BOUNCEX

Floor 74

SUBMITTAL REVIEW

Submittal: BOUNCEX_SignLocation Plans R3_190426

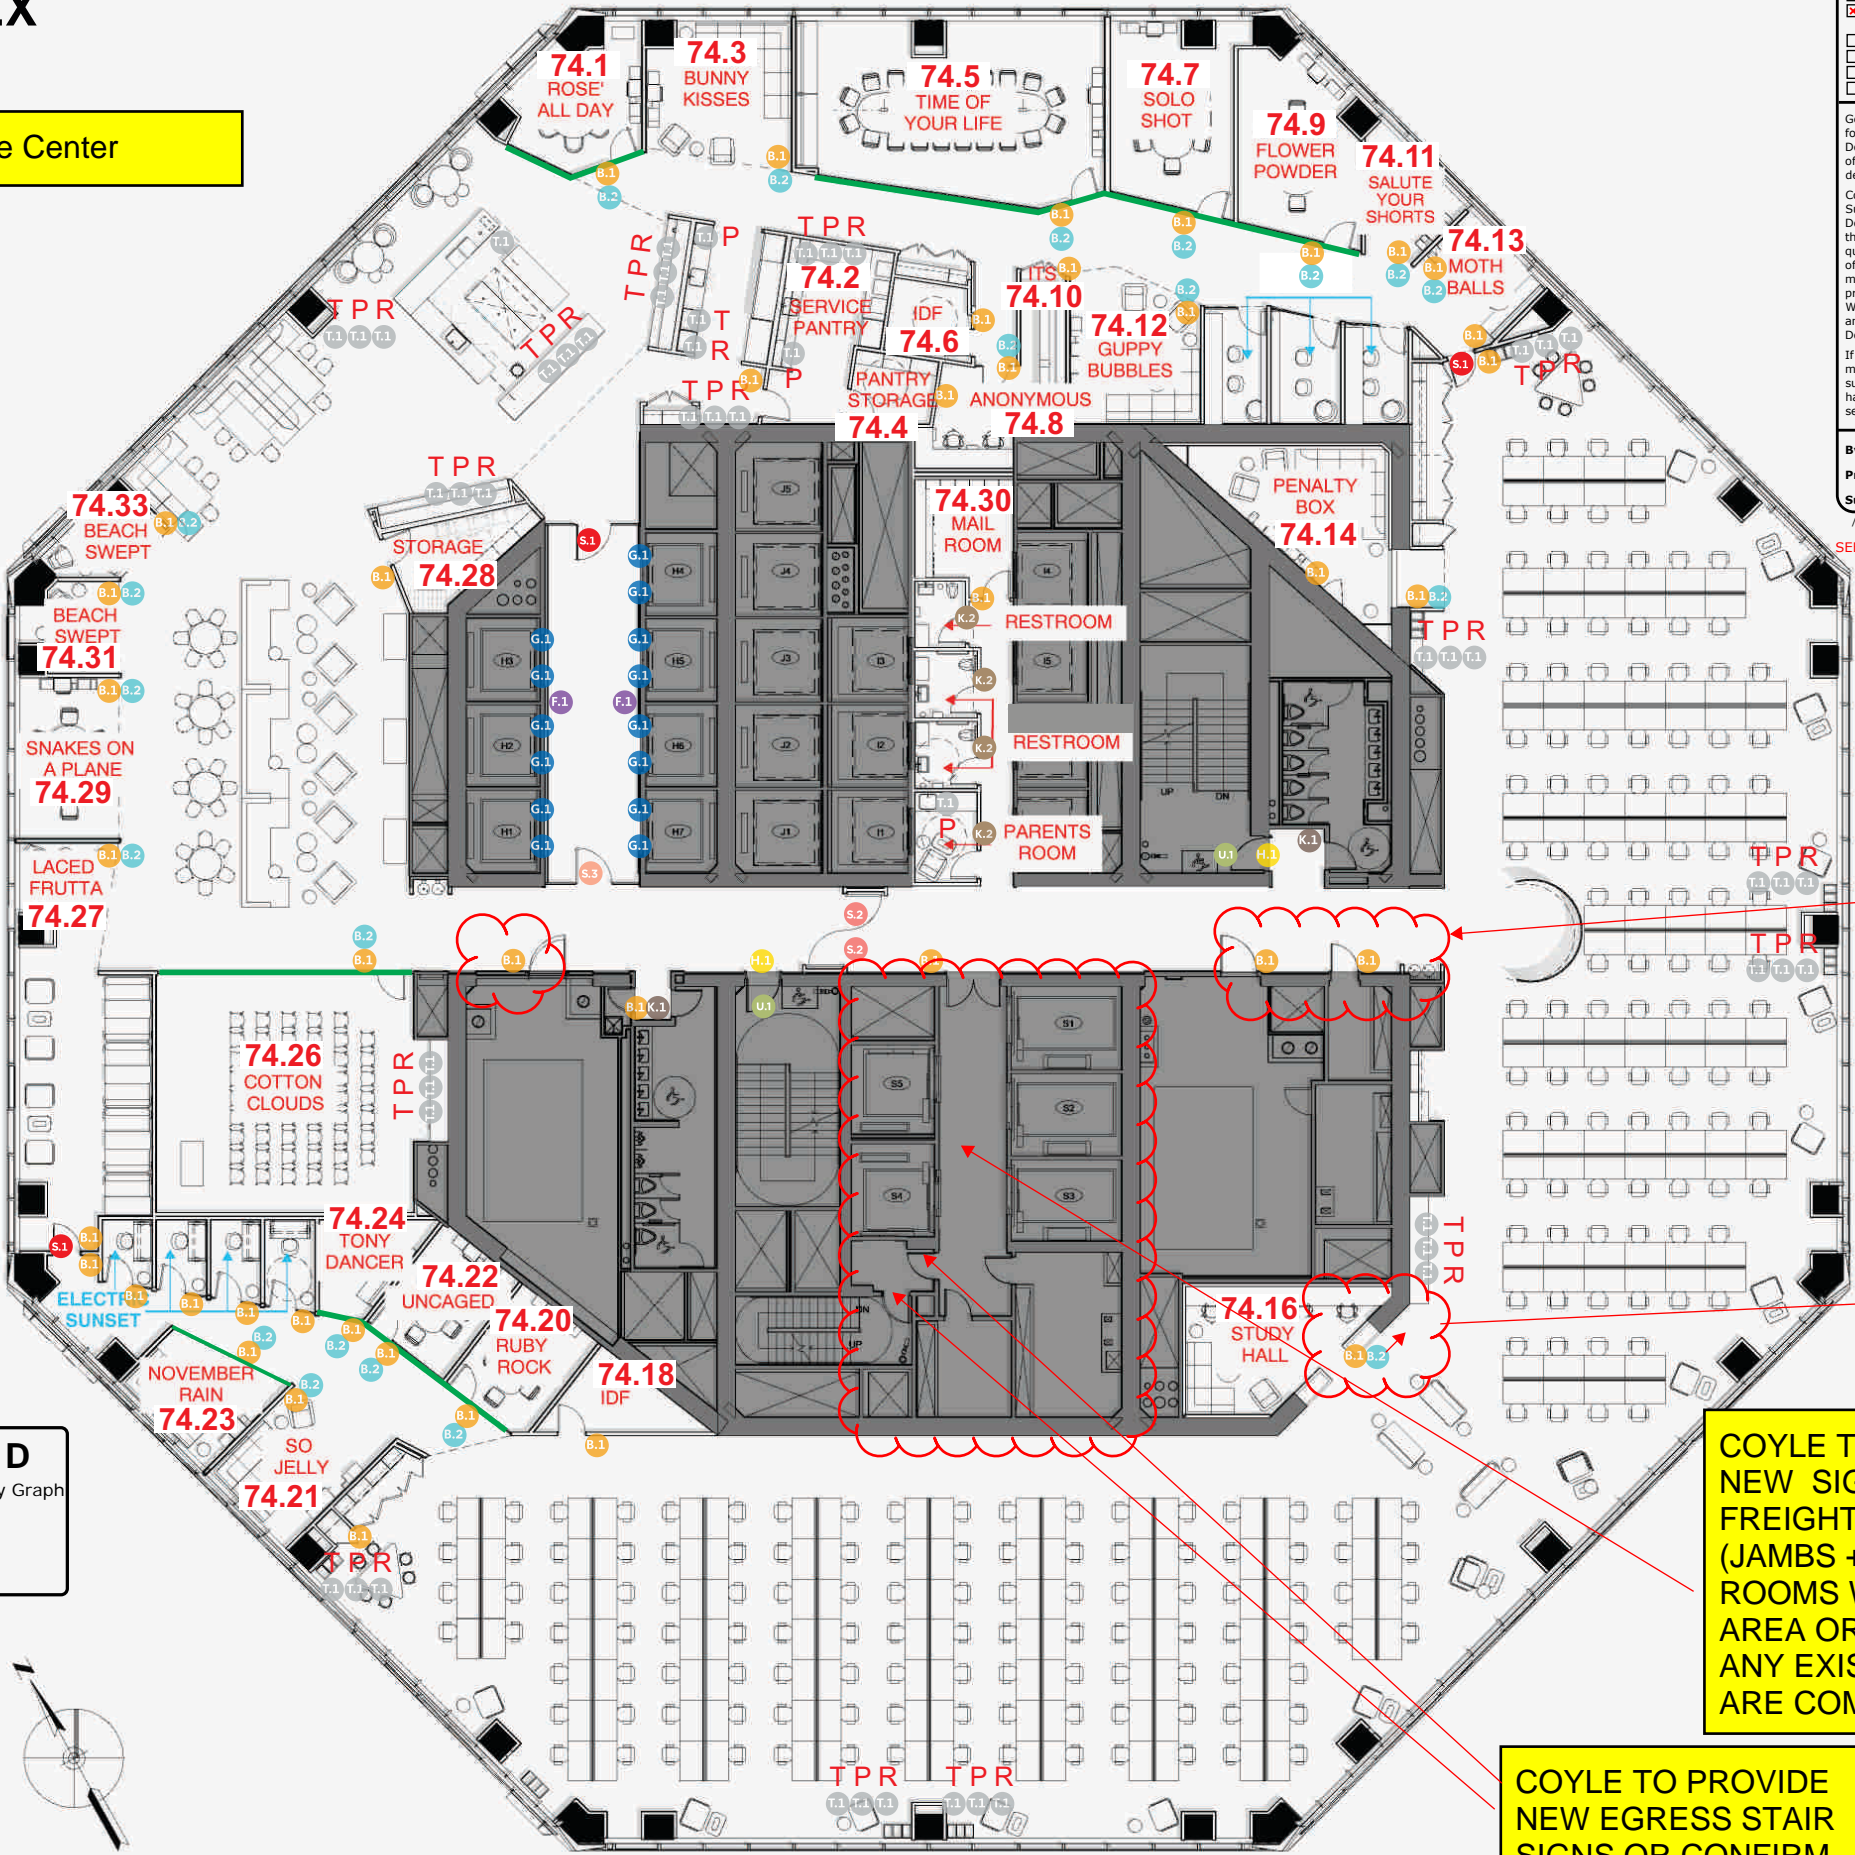
GENERAL NOTE FOR CONCRETE CORE WALLS: COYLE TO COORDINATE SIGN INSTALL FOR AFTER ART MURALS ARE COMPLETED

SHIFT SIGN TO THE RIGHT, SO NOT AT LOW PARTITION

COYLE TO PROVIDE NEW SIGNS FOR FREIGHT ELEVATORS (JAMBS + EGRESS MAP)+ ROOMS WITHIN FREIGHT AREA OR CONFIRM THAT ANY EXISTING SIGNS ARE COMPLIANT

COYLE TO PROVIDE NEW EGRESS STAIR SIGNS OR CONFIRM THAT ANY EXISTING SIGNS ARE COMPLIANT

NOTE: THIS WAS SUBMITTED BY COYLE AS PART OF THE SHOP DRAWINGS FOR "SIGN LOCATION PLANS". NEXT REVISION, COYLE SHOULD INCLUDE A TITLE BLOCK TRACKING ISSUANCE DATES
